CONSTRUCTION PLANS
FOR
**CARRIAGE MEADOW SOUTH AT
LORSON RANCH FILING NO. 2**
STREET/STORM SEWER AND UTILITY CONSTRUCTION PLANS

Engineering Review

COVER SHEET

STORM SEWER

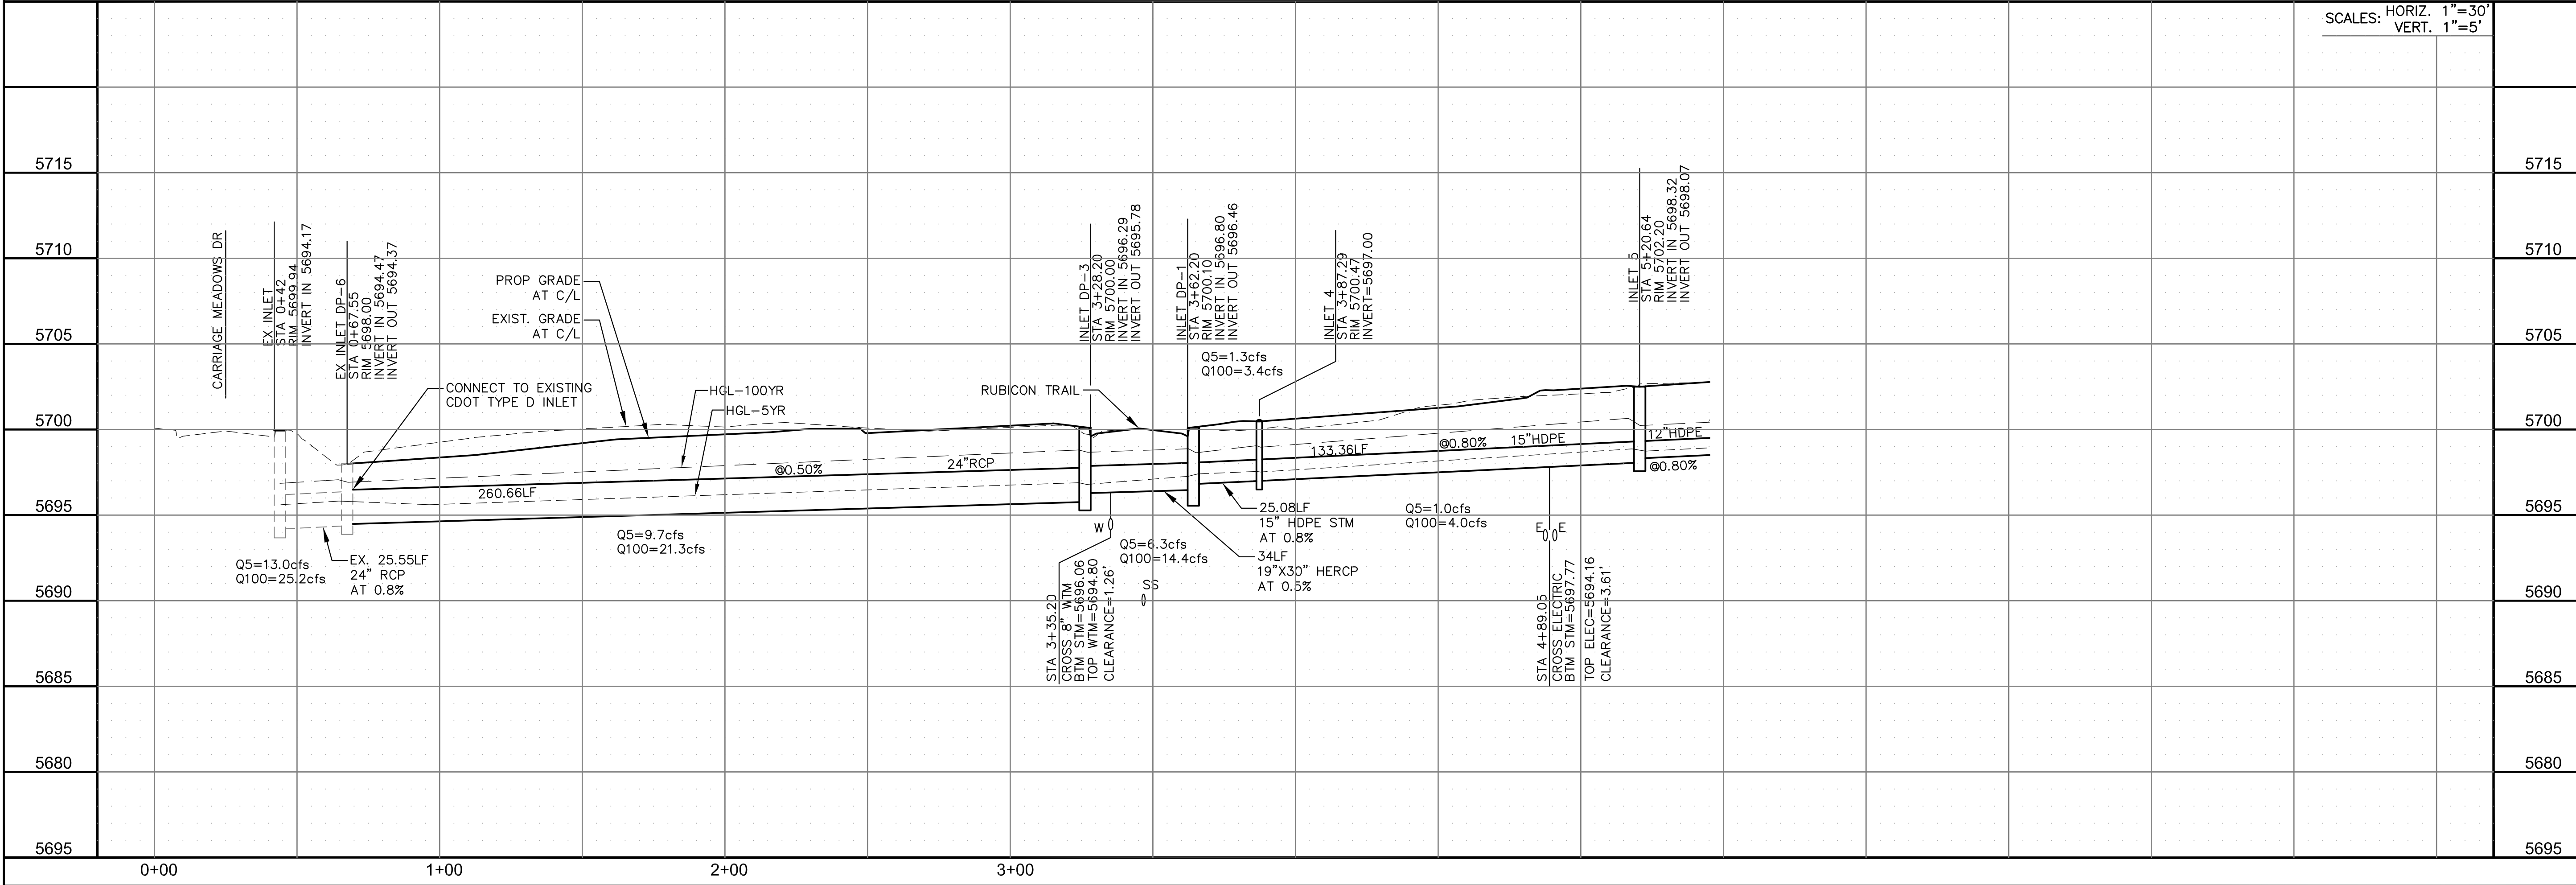
with watertight joints

PRIVATE DRIVE 3 (PALUXY TRAIL) AND HAMMERHEAD

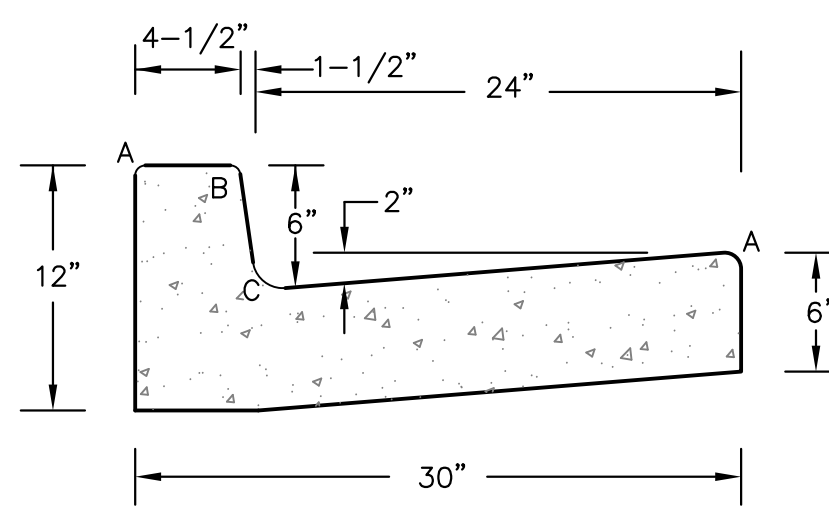
See other comments regarding completion of Carriage Meadows Drive.
